WOODLEY SCHOOL & 6TH FORM

DRAINAGE LAYOUT

Purpose of Issue: FOR REVIEW & COMMENT

Project - Originator - Zone - Level - Type - Role - Number: NWSC-HEX-ZZ-ZZ-D-C-92001

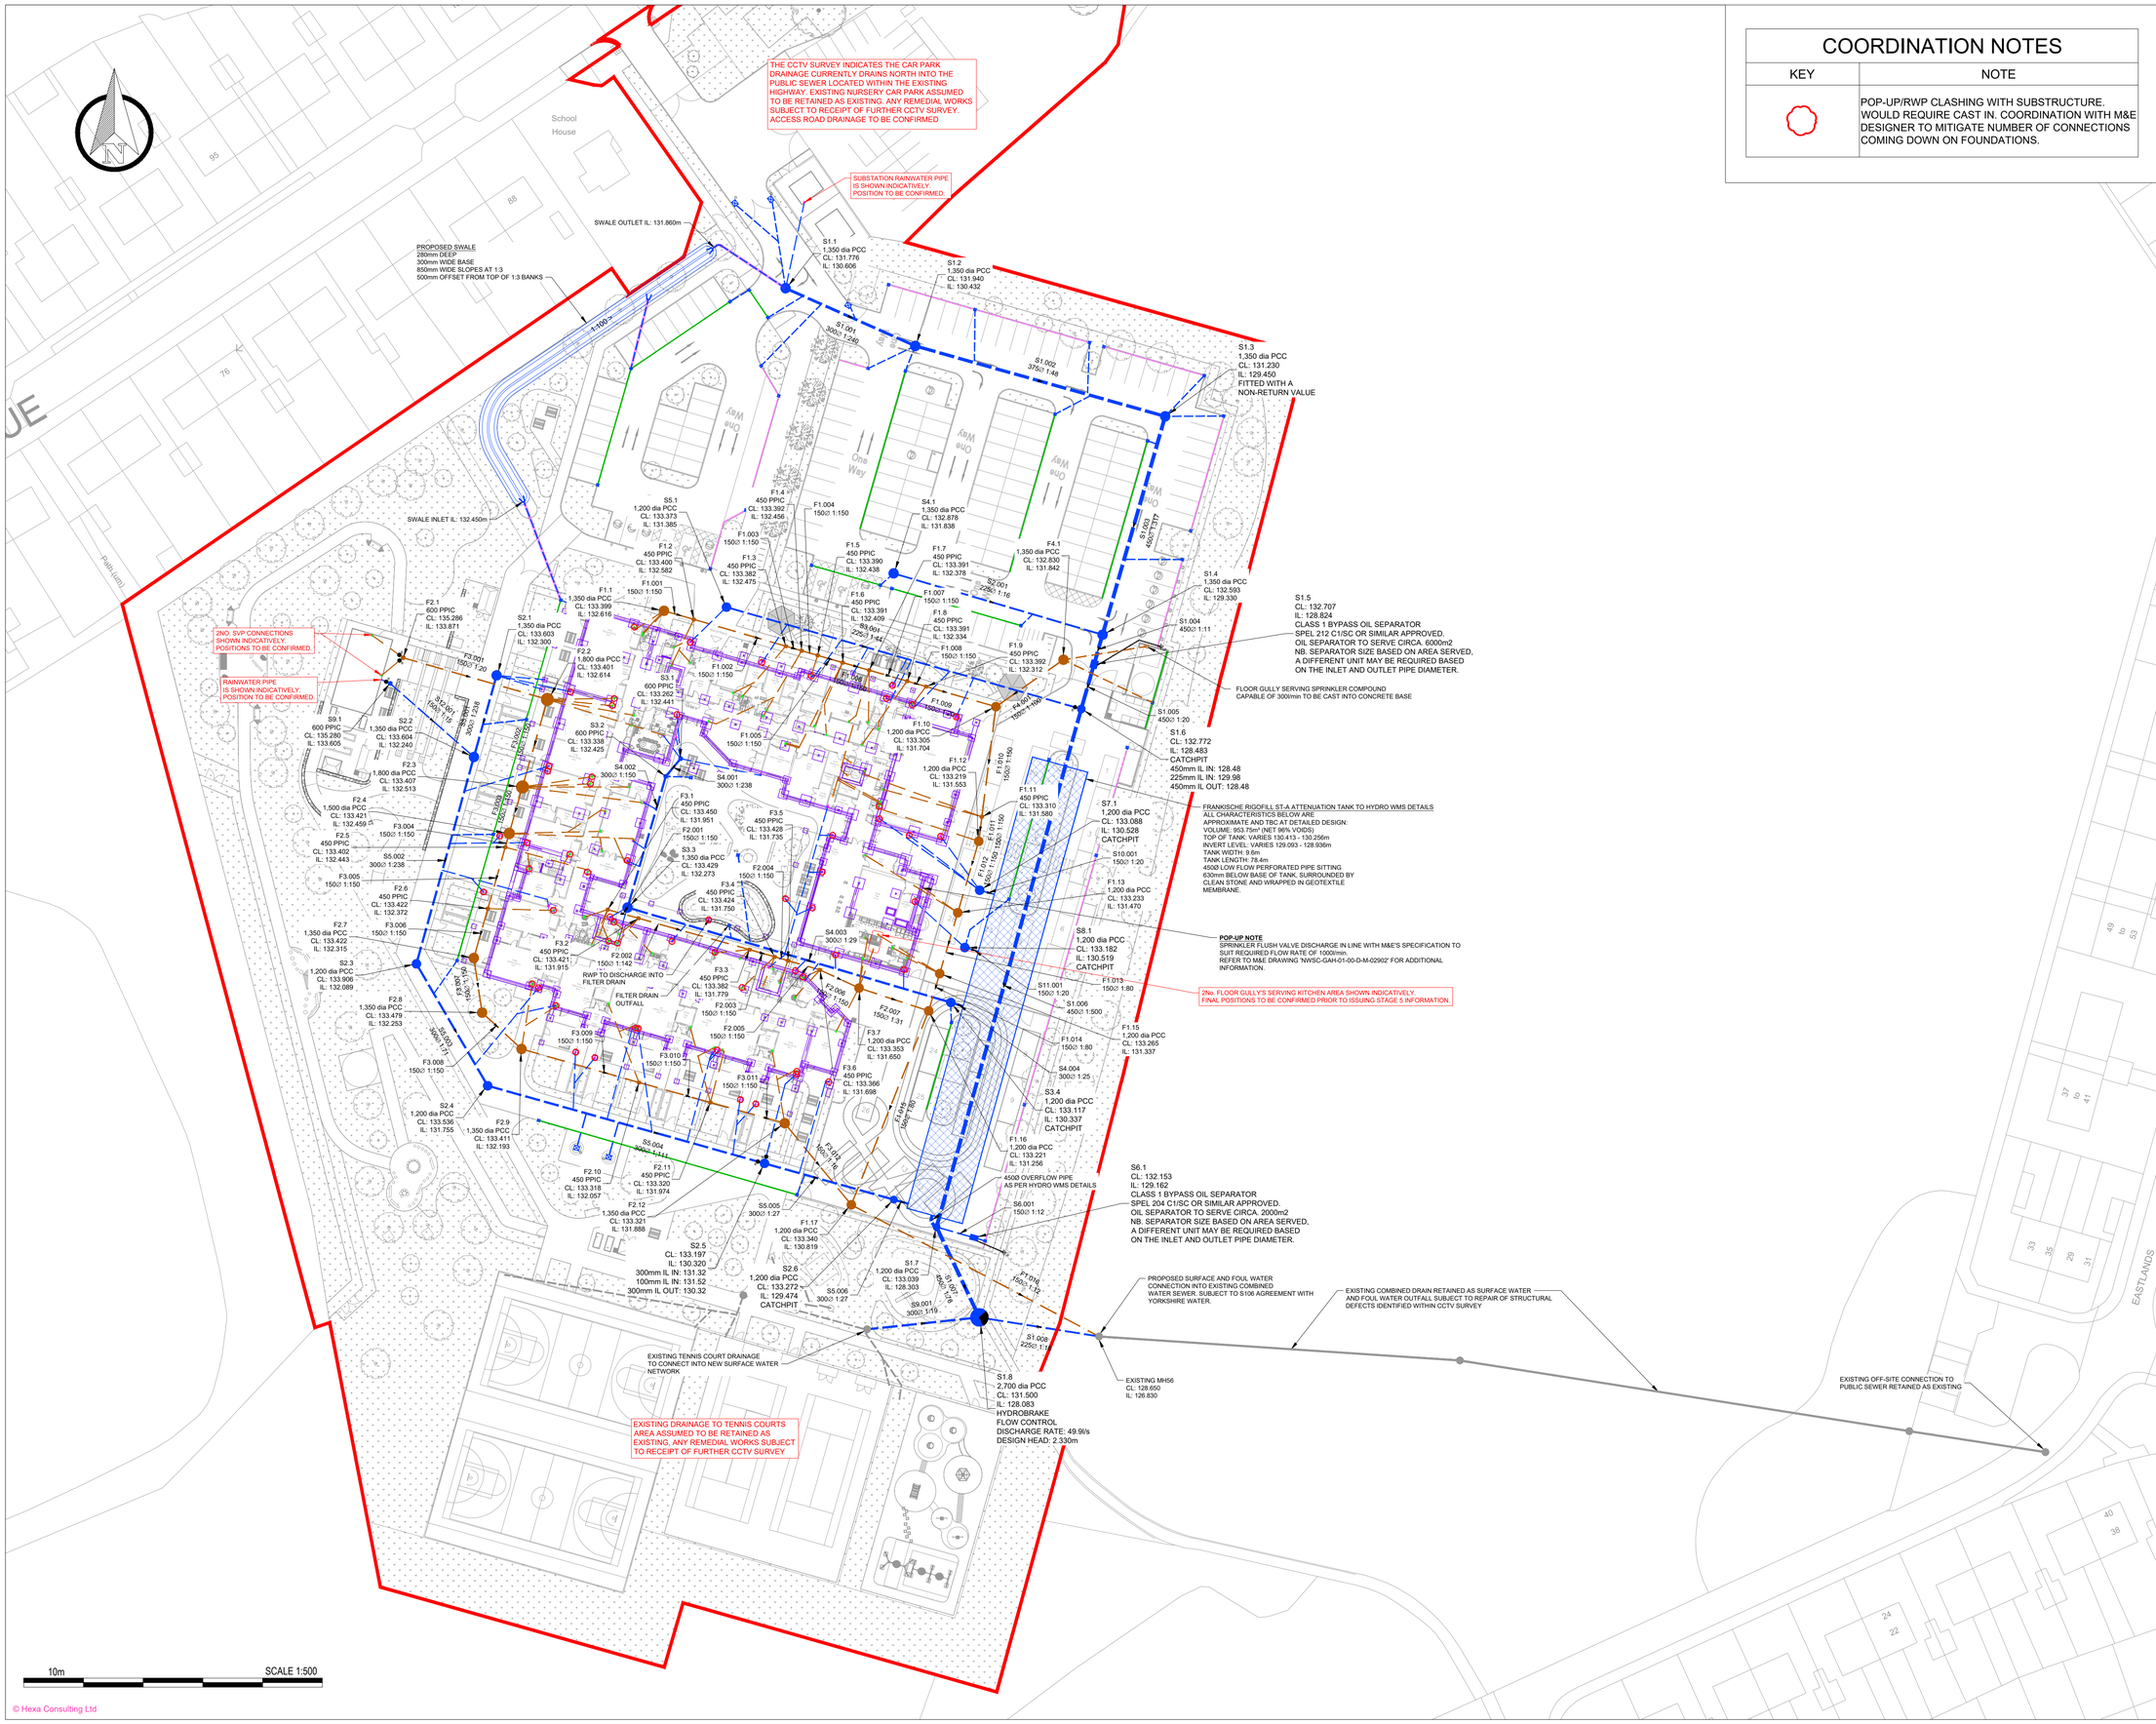
KEY	NOTE
	POP-UP/RWP CLASHING WITH SUBSTRUCTURE. WOULD REQUIRE CAST IN. COORDINATION WITH M&E DESIGNER TO MITIGATE NUMBER OF CONNECTIONS COMING DOWN ON FOUNDATIONS.
